UNITED STATES PATENT AND TRADEMARK OFFICE

10/590,638

Office Action Summary	Application No. 10/590,638	Applicant(s) RAMSAUER, DIETER	
	Examiner KRISTINA R. FULTON	Art Unit 3673

DETAILED ACTION

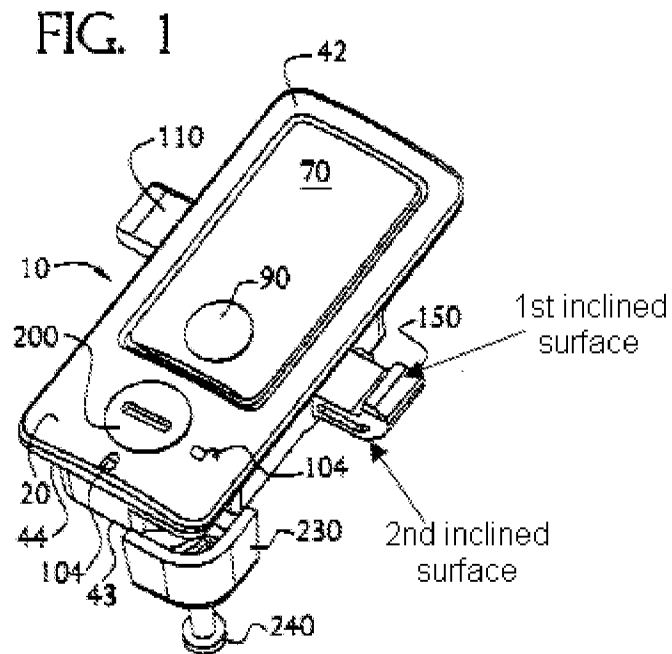
5. Claim 28 requires the holding elements to be in the cylinder 54. Although the figures now show 54 it is unclear from figures 2 and 3 how the cylinder differs from head part. Is the head part of the cylinder?

7. Claim 31 requires the holding elements to be “flexible” yet further in the claim limit the material to a “rigid material”. It is unclear how the holding elements are “flexible” yet made of “rigid metal”. The claims have been examined “as best understood”.

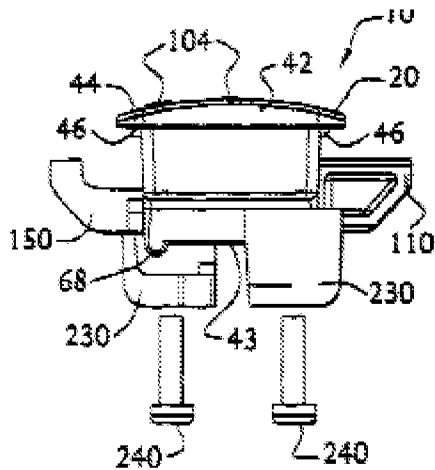
9. Regarding claims 28, 31 and 34, Vickers teaches a latch having a head part (42) arranged outside a thin wall, a body part (20 below 42) which proceeds from the head part and projects through the opening in the mounted position, holding elements (110 and 150) which project from the body part and are flexible in a direction, a free end of the holding elements being provided with an inclined surface (see figure below) for supporting the body part without play on the rim and said free end of said holding elements being further provided with a second inclined surface (see below) for slam action, the body part and the holding elements being separate parts and the holding elements being slides. Please note "as best understood" for the last limitation of claims 28 and 31 and claim 34, Vickers shows a lock cylinder (200) associated with holding elements (110 and 150). If applicant intends to call the head part of the cylinder then please note that applicant's "cylinder" is as much as cylinder as Vickers 10 shown in figure 1.

10. Regarding claim 29 “as best understood”, Vickers shows the slides are held against a pressure spring force (198) by a hook arrangement (tabs and slots seen in figures 9 and 10).

11. Regarding claim 31, Vickers teaches the claimed limitations as applied to claim 28 above and further teaches “as best understood” that a slides are held by a spring force (198) and a pin arrangement (tabs and slots of figures 9 and 10). See the Vickers device below.

Applicant's arguments filed 8/18/09 have been fully considered but they are not persuasive. Vickers shows two inclined surfaces as labeled above. Please note that applicant should focus on structural differences as the prior art has the claimed structure and is capable of performing the claimed functional language (the "for" language). Applicant should not rely solely on functional language to define over the prior art.
